STATE OF CALIFORNIA	Job Stamp	7-day Const. Calendar	Day No. 649
DEPARTMENT OF TRANSPORTATION	SFOBB SAS	Project Work Day No.	Day No. 859
Form HC-10A (Rev. 6/80)	04-0120F4	Date	09/22/2008

# REQUEST FOR INFORMATION (RFI)

<b>Subject:</b> #43 Rebar with HRC Couplers	
<b>References:</b>	
<b>Sub/Sup:</b> RSC	<b>Sub RFI #:</b> RFI-RSC-002822R01
<b>Response Required by:</b> 05-September-2008	<b>Response affects critical path activity?</b>

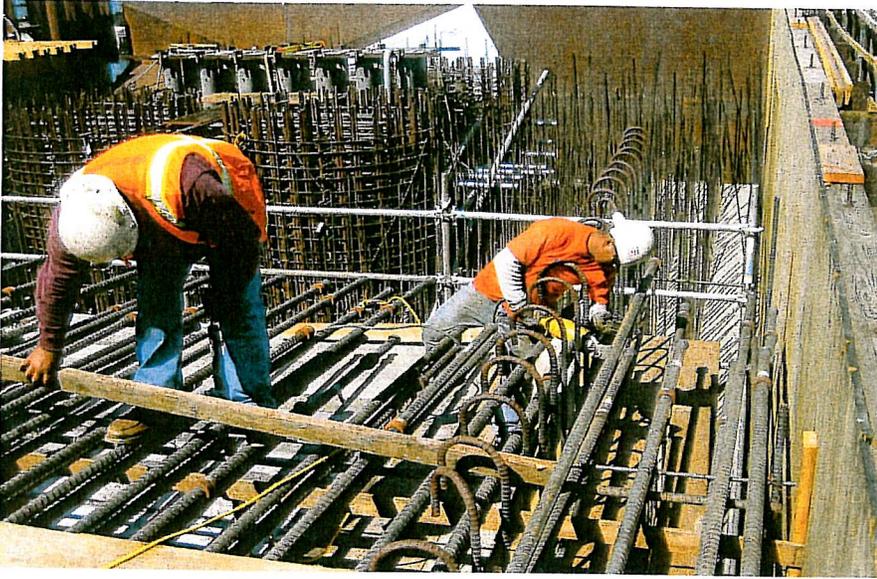
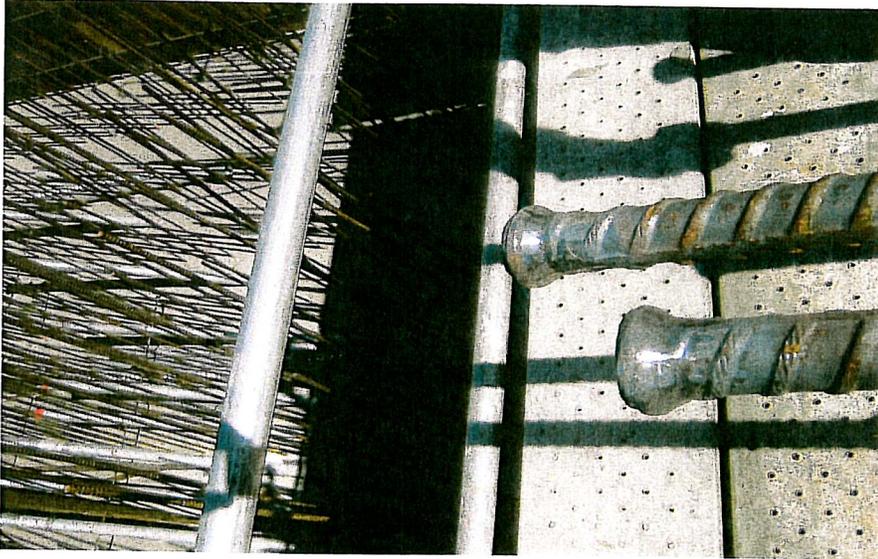
- Ironworkers on site grinding mushroom ends of #43 rebars on north side. See attached RFI #1494R00.

The ironworkers grinding mushroom ends of #43 rebar.

Finished mushroom ends.
